RE:	CHANGING MAIN SHAFT MOTOR
Models	TFGN2, TFGN2-C, TFSN
Sections Changed	Main shaft motor (1.5KW) Bracket and Cover for Main shaft motor
Reasons	
	Because the current motor has been suspended from production
Schedule	From May 2015
Introduction	
MFG. Numbers Applicable	(*) Please refer to MFG.Numbers table on the bottom of this page. Click here to move to the table
Compatibility	NO
Accommodation to Customer-installed Machines	Not Necessary, Not Available
Details

2. Change of Bracket, Cover

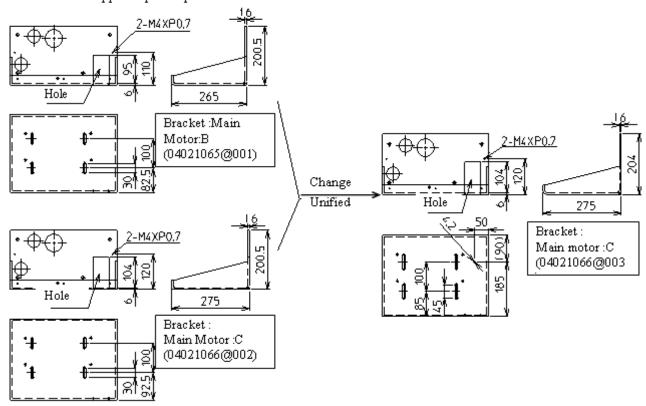
According to the change of the motor, the bracket and cover also are changed.

The bracket/cover after change can be used also for the motor before change and the motor (high efficiency) after change. Before the change, the cover was in two types used depending on the length of Arm Support Square Pipe. After the change, the cover is unified to one type.

(1) Change of Bracket

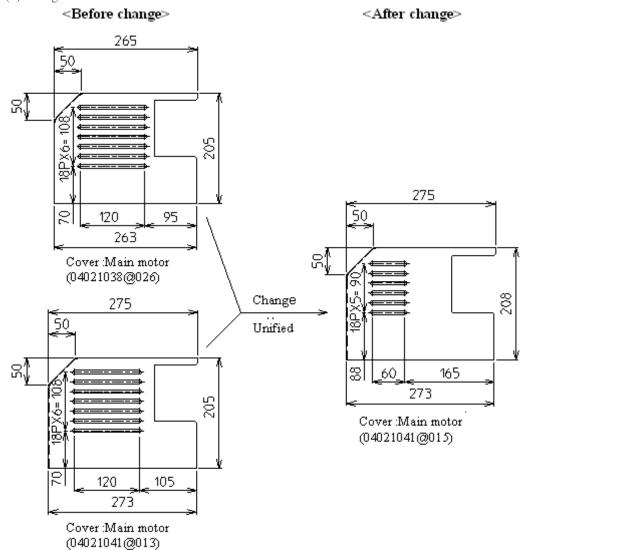
<Before change>

<After change>

Upper: Arm Support Square Pipe 300mm Lower: Arm Support Square Pipe 400mm
